**WOKINGHAM
BOROUGH COUNCIL**

Discharge of condition Consultation

Site Address: Nigra Building (The Mulberry Centre), Mulberry Business Park,
Fishponds Road, Wokingham, RG41 2GY

Proposal: Application for submission of details to comply with the following condition of planning consent 242136 dated 06.01.2025. Condition 8 relates to Construction Method Statement.

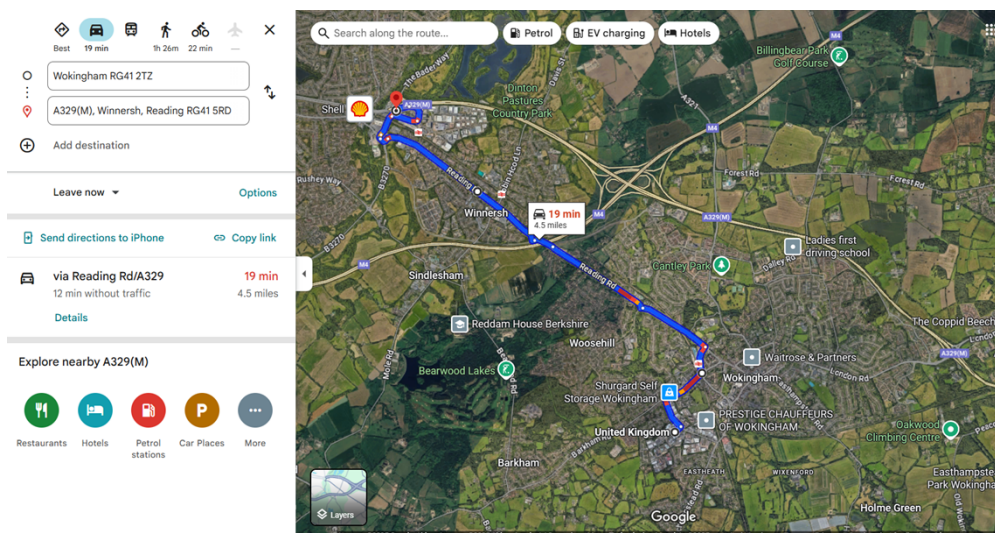
- a) The LHA require the HGV route to be amended to avoid the roads within Wokingham Town Centre. The route suggested by the developer shows HGVs routeing along Rectory Road which would only facilitate departures; and Wokingham's one-way system means arrivals would enter via the Peach Street/Broad Street Route due to Wokingham's one-way system. It is not desirable to increase number of vehicles using Peach Street/Broad Street to protect both Highways Safety and Air Quality. This is because it has high levels of pedestrian activity and falls within the Wokingham Town Centre Air Quality Management Area (AQMA). The Wokingham AQMA is shown below.

WBC require the construction HGVs to join the motorway at the A329M/A3290 Winnersh Junction. The HGVs should use Barkham Road, Station Road and Reading Road (A329) as shown below:
